Re: As-Built Baseline Report and Drawings for Hornpipe Branch Tributaries Site
(#100076)

RE: WLS Responses to NCDEQ DMS Review Comments for Task 6 Submittal, Final Baseline Monitoring Report for the Hornpipe Branch Tributaries Mitigation Project, DMS Full-Delivery Project ID #100076, Contract #7605, Neuse River Basin, Cataloging Unit 03020202, Lenoir County, NC

MYO FINAL MONITORING REPORT
Hornpipe Branch Tributaries Mitigation Project
Lenoir County
Neuse River Basin
CU 03020202

SHEET NUMBER
12

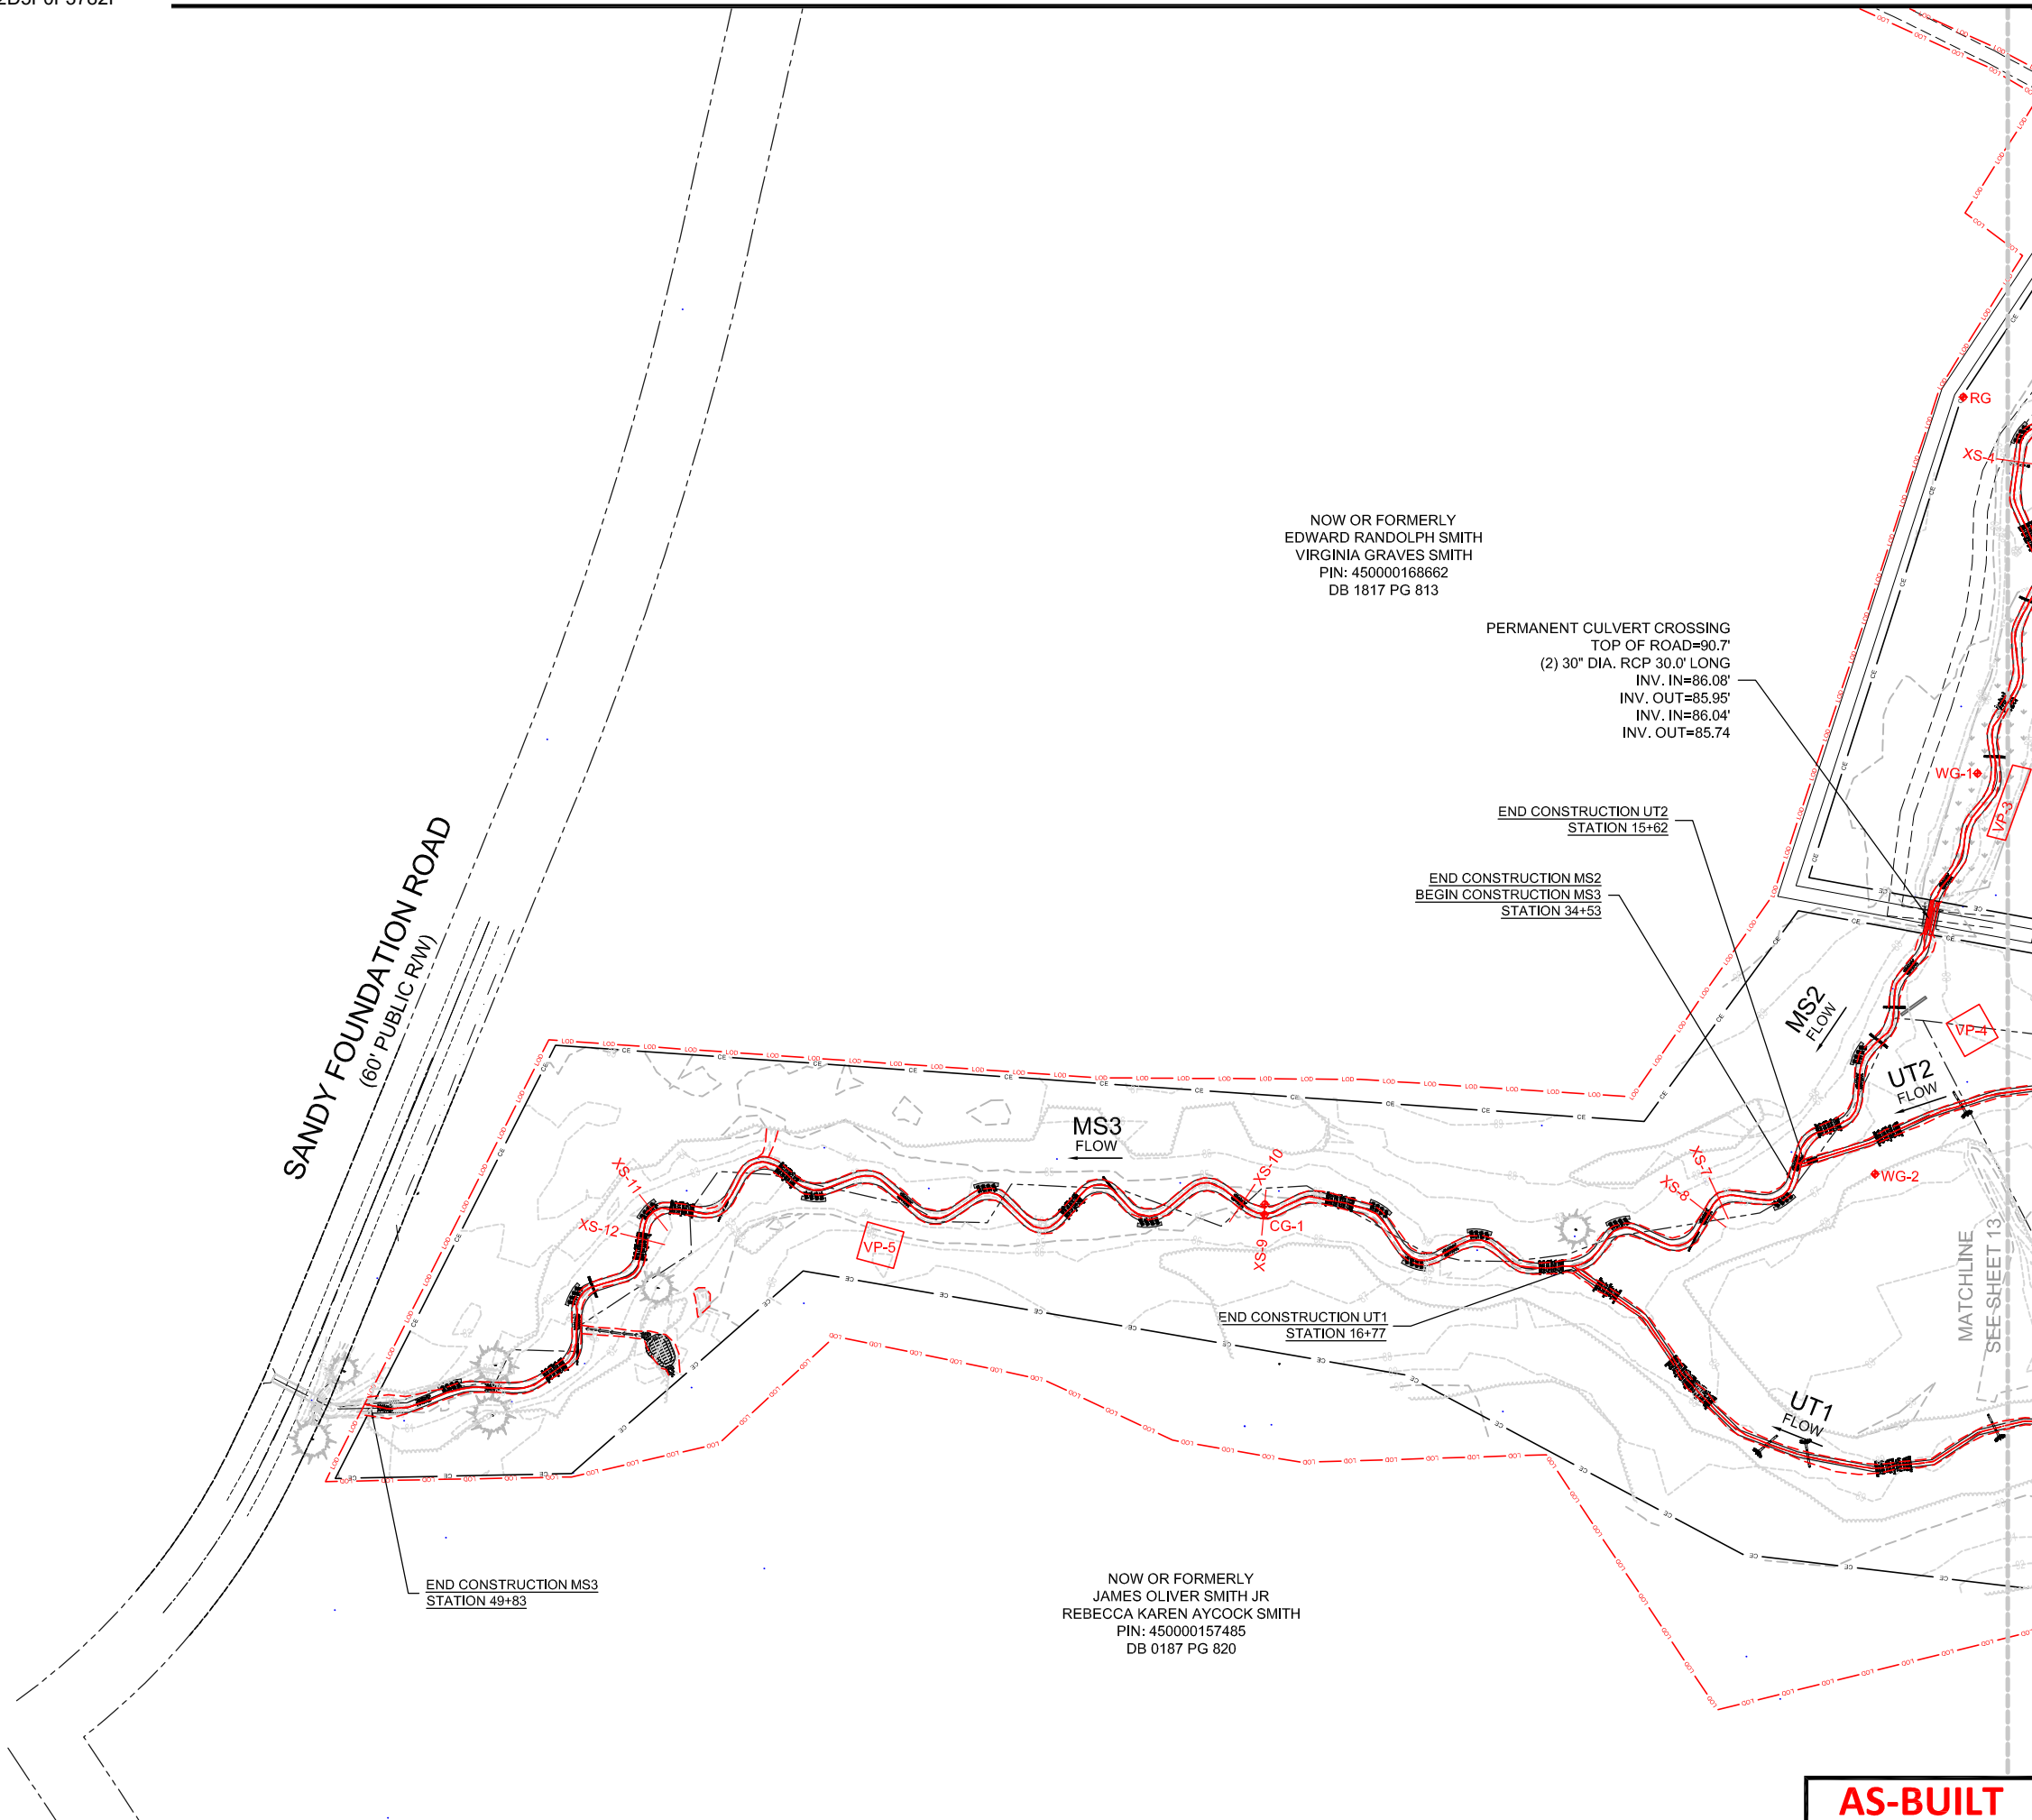
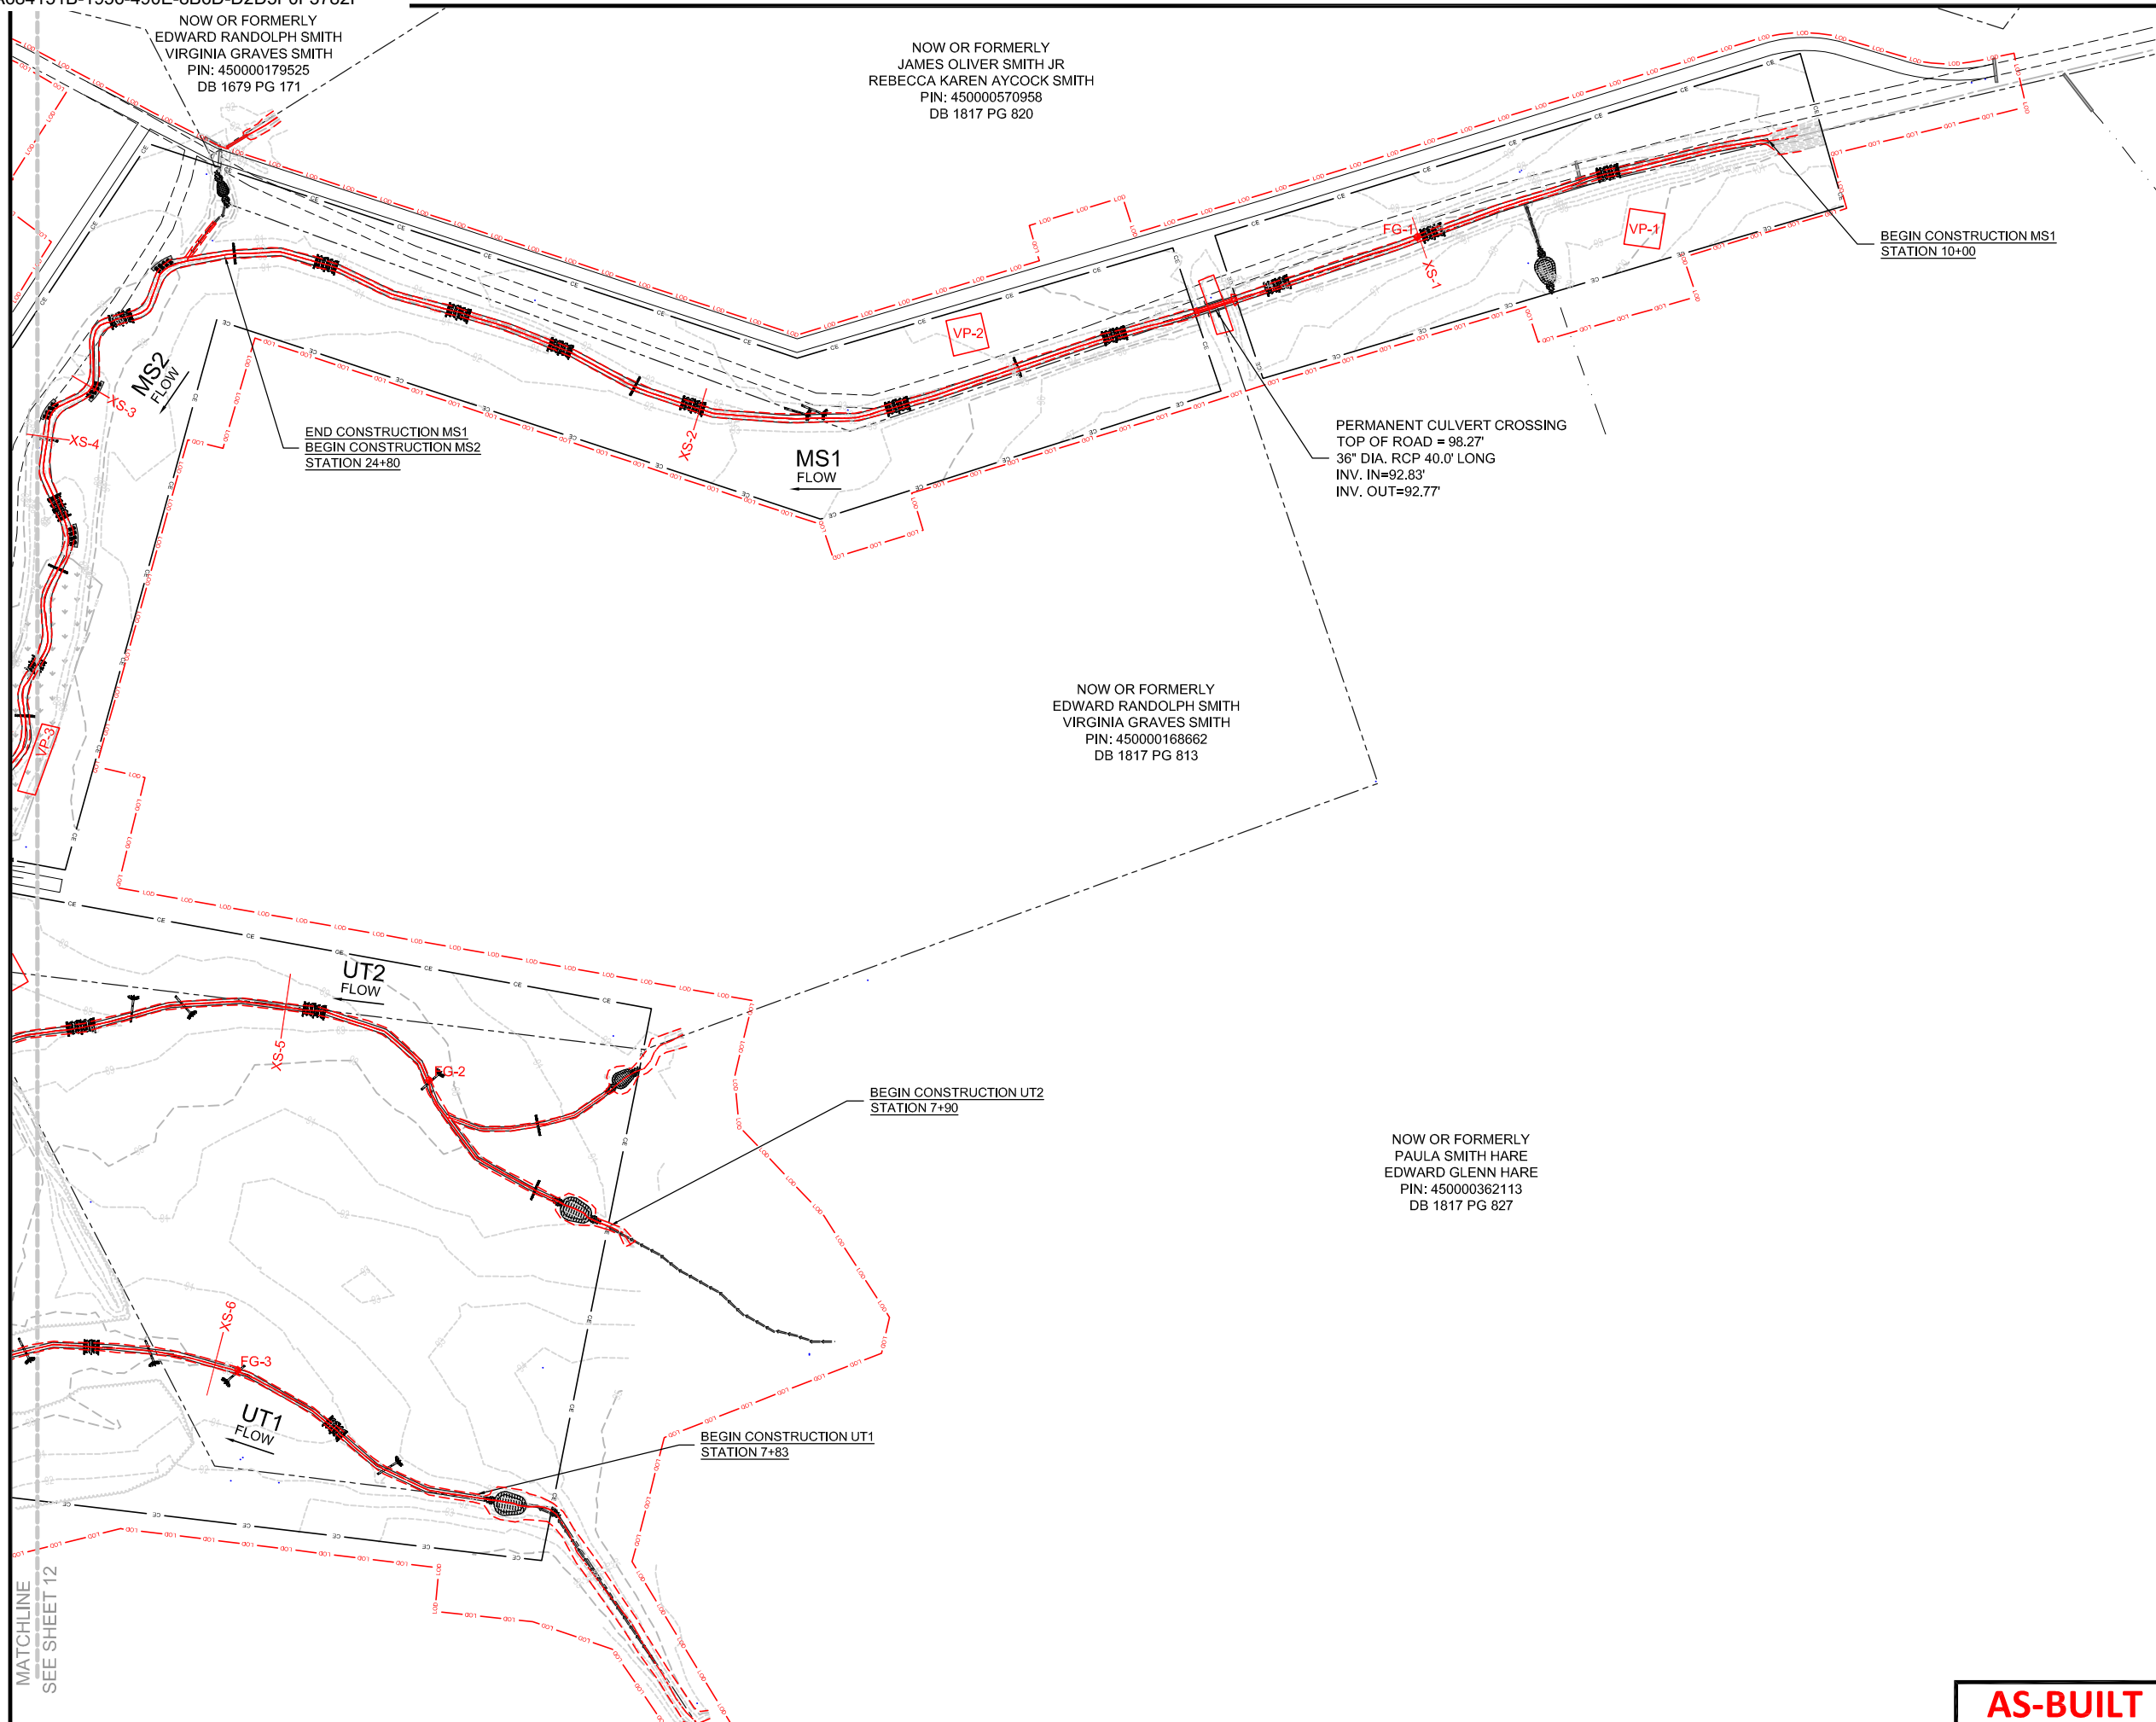
- **Record drawings show that there were 2, 30” culverts installed at the downstream crossing. Comments during the Mitigation Plan indicate that WLS was designing the stream to support one culvert at that crossing based on WRC comments. If this was changed from design please provide a comment to that affect and explanation why the double culvert was installed there.** Response: Based on the IRT response comments, we revised the permanent culvert crossing detail in the final design plans to include one channel culvert and one floodplain culvert(s) with adequate two foot spacing. The floodplain culvert was set slightly lower than the floodplain elevation, however a plunge pool was designed at the downstream pipe invert to provide aquatic passage and prevent split flows and deleterious effects to the stream.
